THE ESTATES AT SHADYBROOK

SEDGWICK COUNTY, KANSAS

Re: S/D97-95 -- Final Plat of SHADYBROOK ESTATES

STAFF REPORT

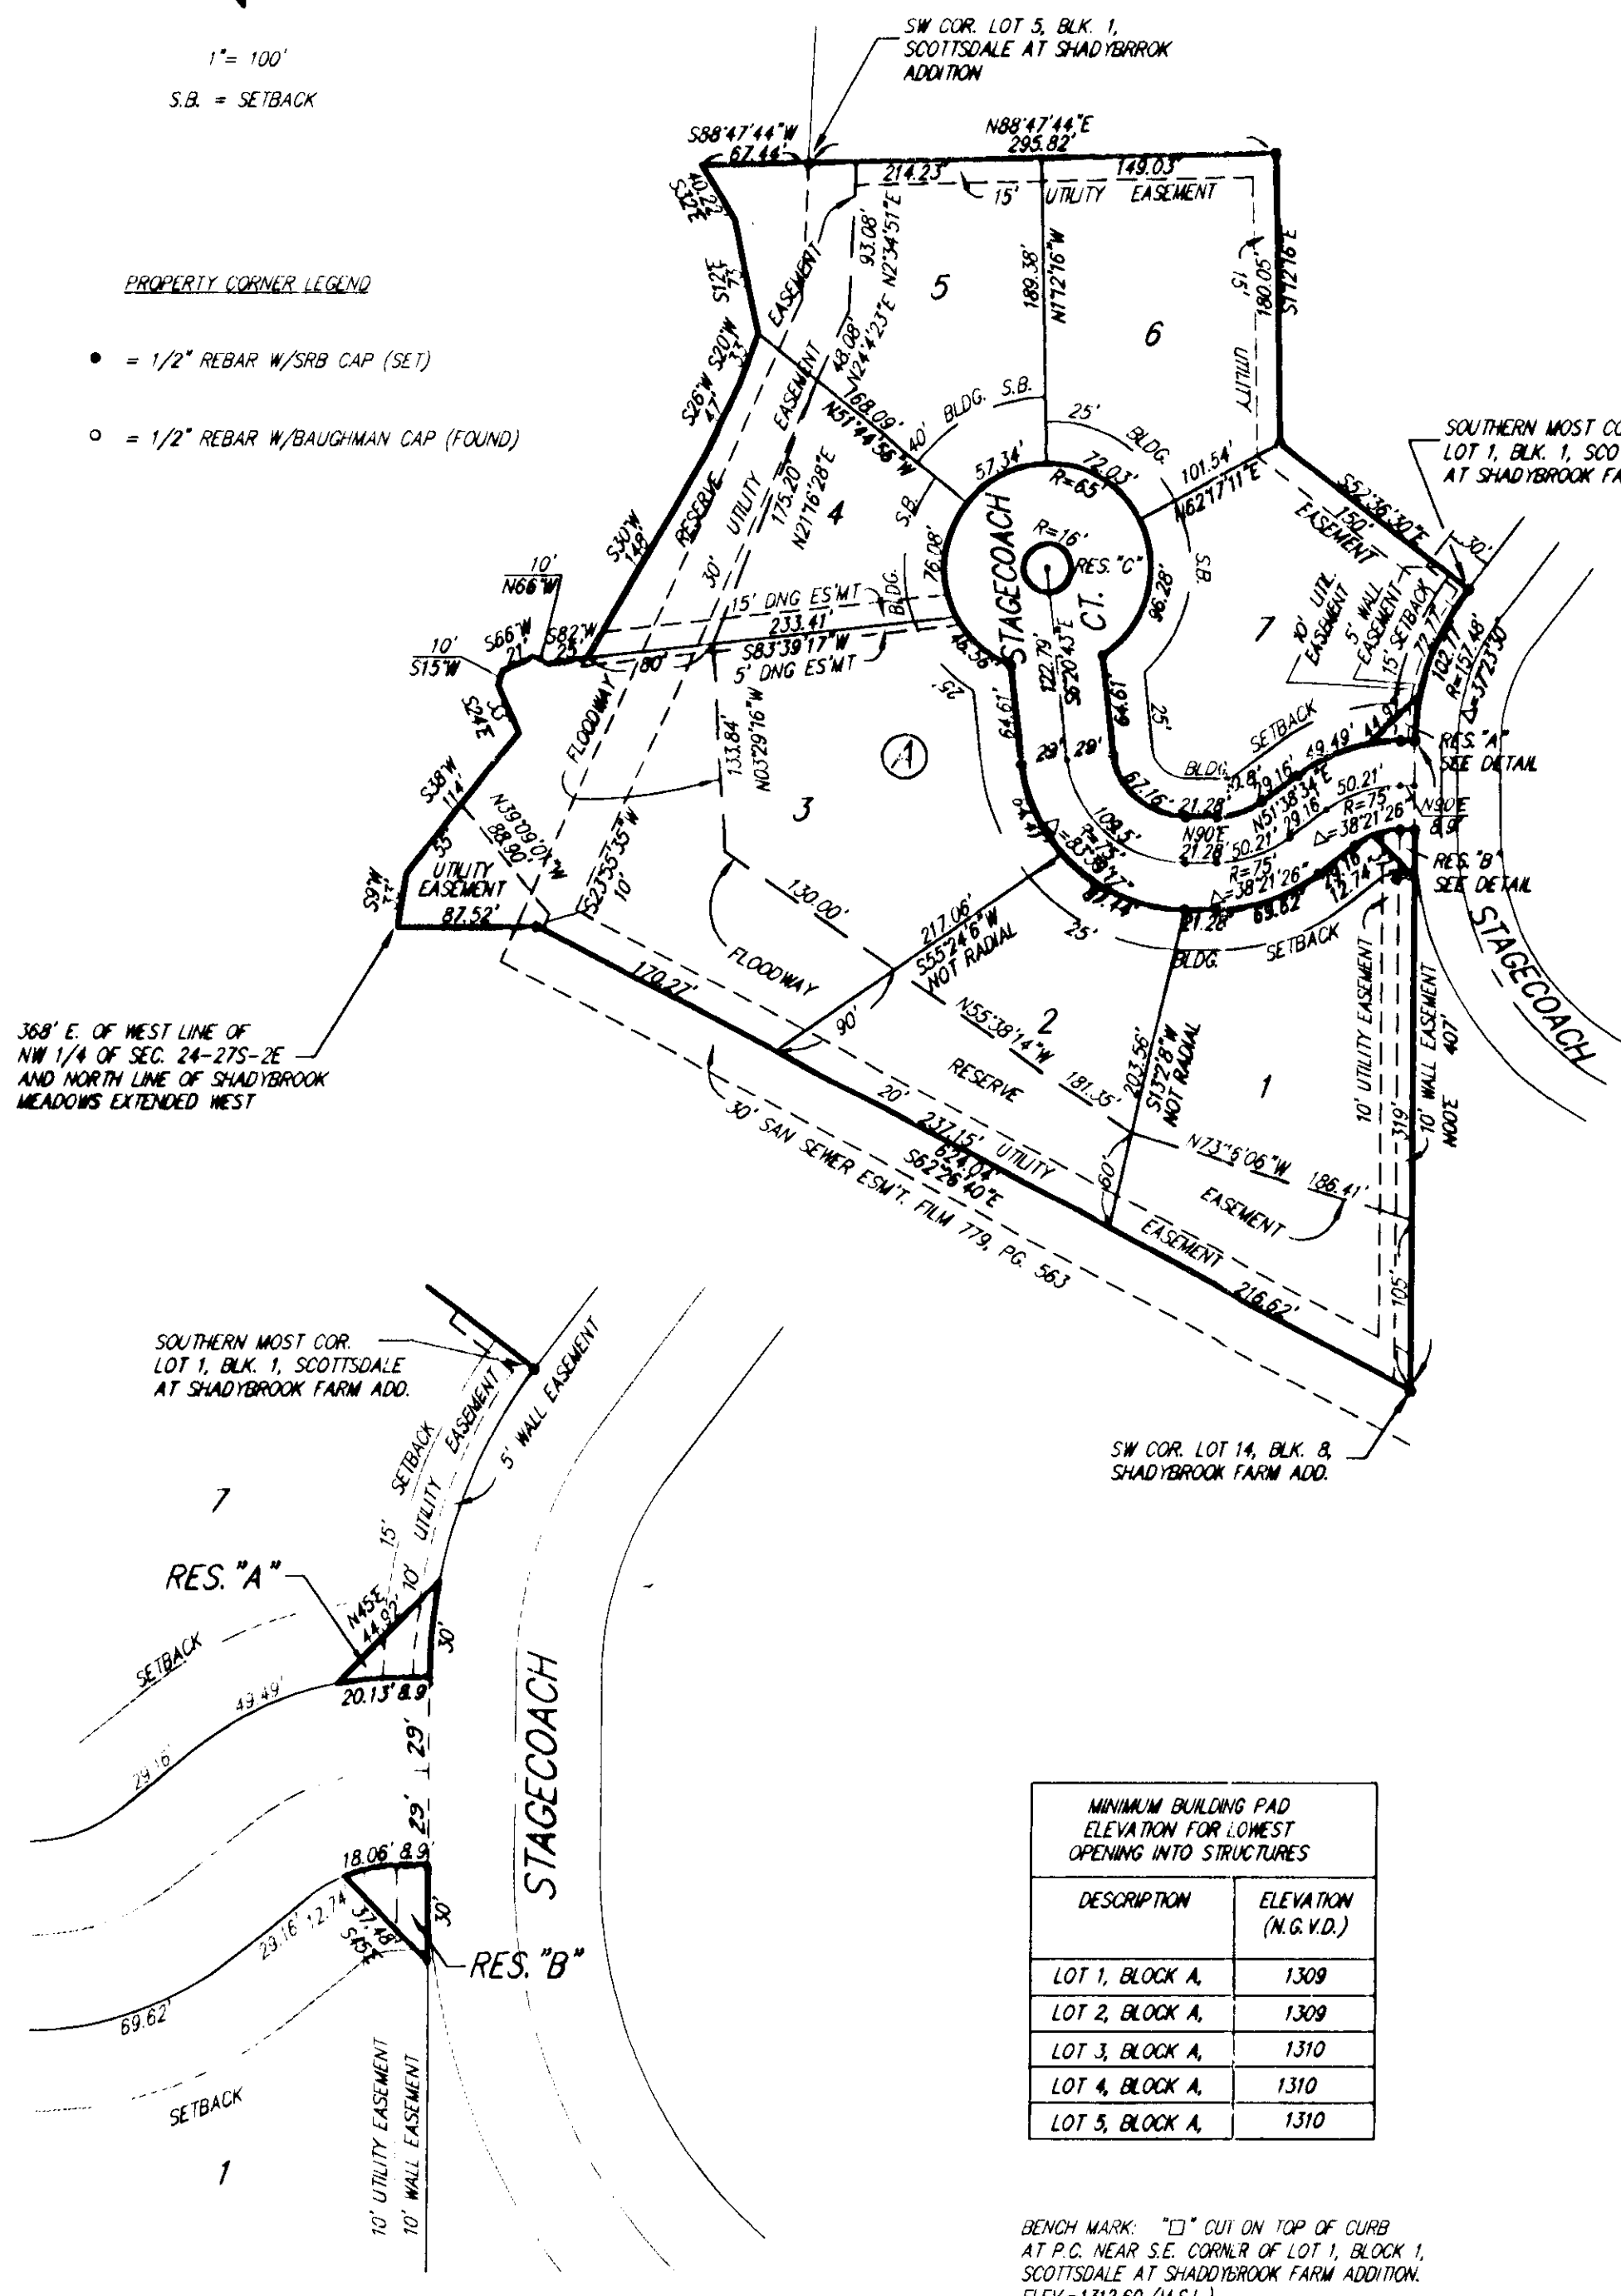
- A. This site is located in the County's Four Mile Creek sewer system and will be served by the County.
- B. The applicant shall guarantee the extension of City water to serve the lots being platted. These improvements will be with the City of Wichita and consequently an outside-the-city water agreement shall be provided.
- C. If improvements are guaranteed by petition, a notarized certificate listing the petitions shall be submitted to the Planning department for recording.
- D. County Engineering needs to comment on the status of the applicant's drainage concept. County Engineering has approved the drainage concept. Minimum pad elevations are requested for the lots adjacent to the creek. Portions of some of the lots are within the Floodplain; and if intended for building sites, these areas will need to be removed from FEMA maps.

→ The final plat has denoted minimum building pad elevations as requested. County Engineering requests submittal of the drainage plan. The minimum building pad elevation for lot 4 needs revised.

- E. → The final plat tracing must indicate bearings that match those described in the legal description. Specifically, the northeast bearing for the north line of the plat would appear to be a southwest bearing; and the southeast bearings for Lots 6 and 7 would appear to be northwest bearings.

K. Lot 5 does not conform with the 100-foot lot width requirement for the SF-20 zoning district. An increase in the distance of the building setback from the road would meet the standard.

- S. The representatives from the utility companies should be prepared to comment on the need for any additional utility easements to be platted on this property. **The representative from Southwestern Bell has requested additional easements as denoted on the attached plat.**

- U. The wall easements need to be referenced in the plattor's text.

✓ On the final plat, the building setback has been increased to 40 feet as requested.
